## SUNDRY NOTICES AND REPORTS ON WELLS

Worth Federal No. 5

## Proposed Plug + Abandonment

**Permanent Abandonment of Federal Wells**  
**Conditions of Approval**

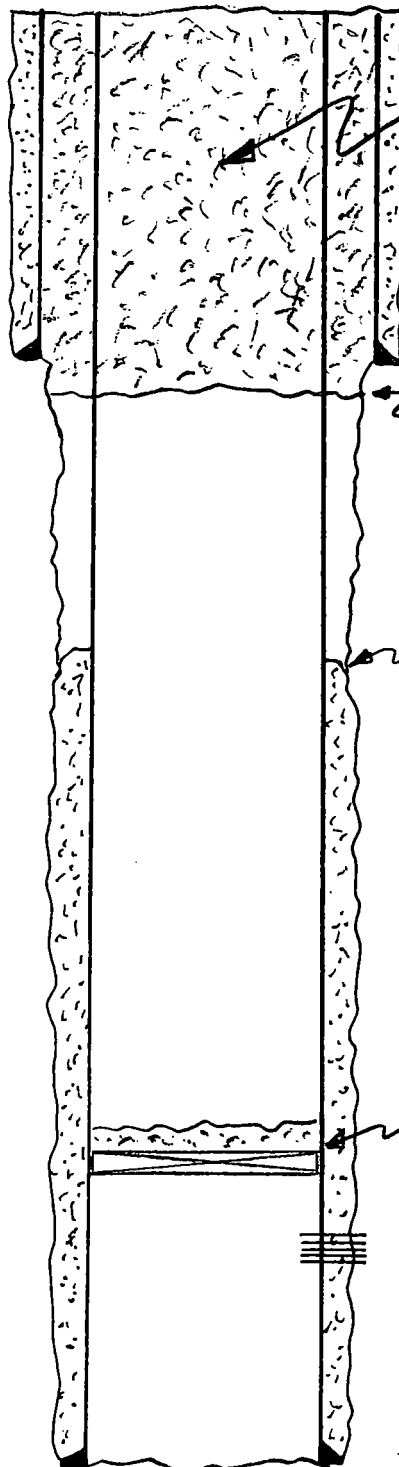
set CIBP between 5062 - 5012. Dump 25' of spot 25 sxs.

Add plug: spot cnt from 4468 - 4318 (DVT, 25 sx min), Tag  
spot cnt from 3117 - 2828 (Del, B/salt). Tag-
